Generator Baggage Door Ventilation

Bulletin Type:	SRP	Publication Date:	July 2022
Bulletin #(s):	22-061	Make(s):	Jayco & Entegra Coach
Job Code(s):	<i>If affected unit has warranty remaining, submit your claim following the normal process</i>	Model(s):	Alante and Vision with 4K Generator
Flat Rate(s):		Model Year(s):	2021-2022

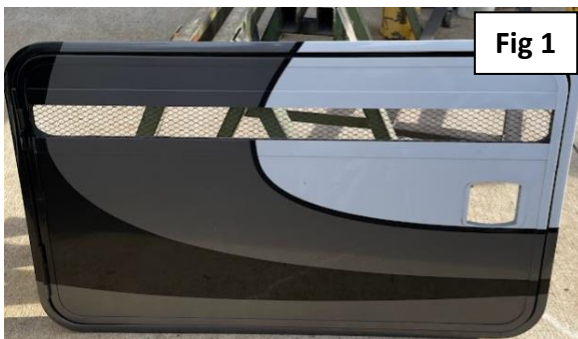
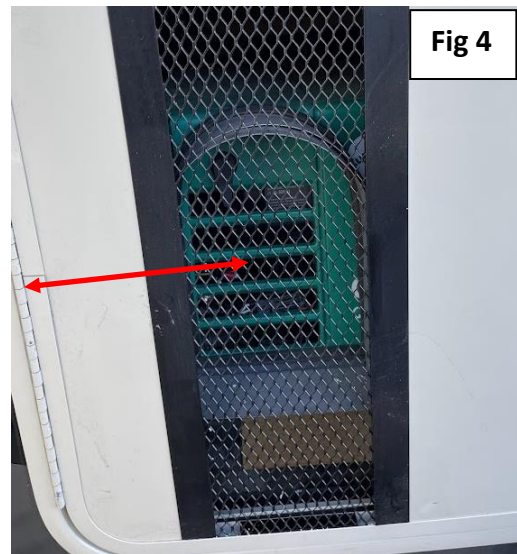
1. Begin by inspecting the generator door which is located on the driver side behind the front wheel.
2. If the generator door looks like Figure 1, then it will need to be replaced with the door in Figure 2.

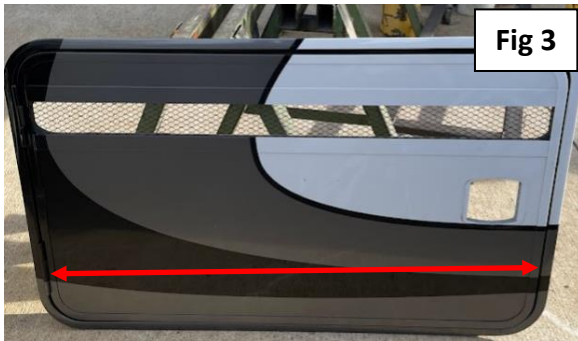
3. In order to determine the correct door size, Jayco Parts Department will need to know the door opening width of the current door installed as shown in Figure 3.
4. In order to determine the correct vent opening location, Jayco Parts Department will need to know the dimensions from the forward door opening to the center of the generator air intake as shown in Figure 4.

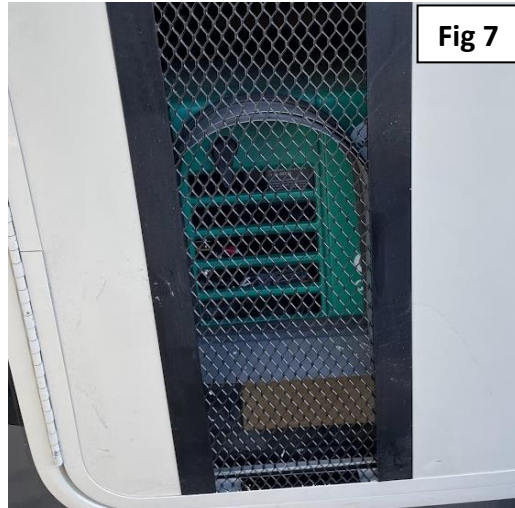
1. Install the new generator door with 2 to 3 screws into each side. Please test door to see if closes completely.
2. Continue with opening the generator door and holding the air intake up to the generator as shown in Figure 5.
3. The correct location would have the gasket seal touching the generator and surrounding the generator intake. Verify the gasket seal touches the generator.
 - A. NOTE: The outer flange of the air intake can adjust outwards if needed.
4. Drill (4) 3/16" mounting holes through interior metal of the generator door. (Figure 4 marked with orange arrow)
 - A. NOTE: Drill bit must not go through exterior skin.

5. With rivet gun, secure the air intake to the back of the baggage door at (4) locations (Figure 6 marked with green arrow).
6. Close door and verify that the rubber gasket touches the generator and the door can still close (Fig. 7). Complete the installation of the generator door by installing the handle and graphic. Contact Jayco Customer Service Parts Department for the graphic.
